CALIFORNIA COASTAL COMMISSION

A-5-LGB-21-0043 (LOHBACH STUDIOS)
AUGUST 13, 2021

EXHIBITS

Project Site: 1007 Gaviota Drive, Laguna Beach (APN: 644-076-01)

SITE / ROOF PLAN

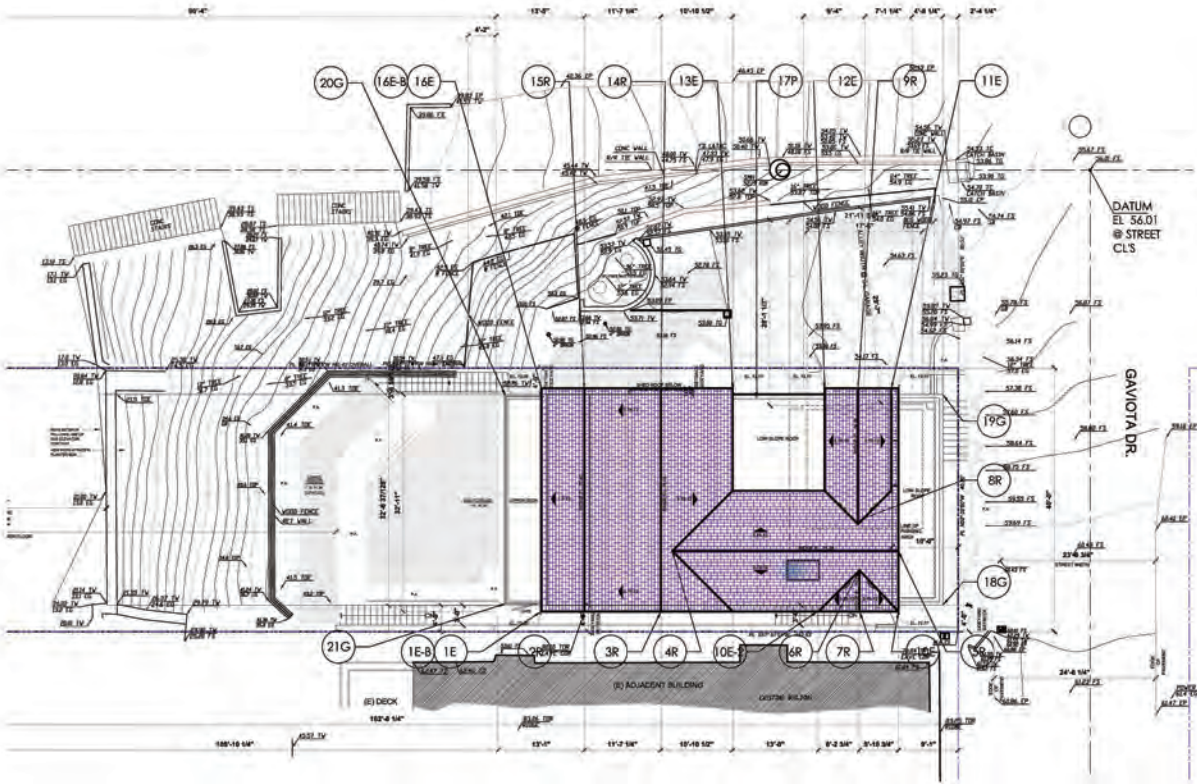
I did not take notes in the meeting but there was a follow up email exchange where I advised Dr. Trigg: "I'm available for a follow up call if needed. The home should be designed with a 25 foot setback from the bluff edge based on the definition in the Land Use Plan, part of the certified Local Coastal Program."

The staff report references a virtual meeting held on June 23, 2020 between the City, the applicant team and CCC staff where CCC staff indicated that "the location of the bluff is at the oceanward side of the uppermost terrace wall". Is that correct? Could you please let us know the decisions that were made at that virtual meeting regarding the bluff/bluff edge?

An additional concern with the 1007 Gaviota project is the applicant appears to be proposing to use City right-of-way for a private driveway and patio. A few feet of encroachment on Gaviota may be consistent with the pattern of development, but no portion of the public access way and public view corridor down Anita Street should be sacrificed for private development. CCC staff met with the property owner on the site about two years ago and identified all of these issues. Please ask the property owner to revise the plans and include findings in the City's record to address these concerns.
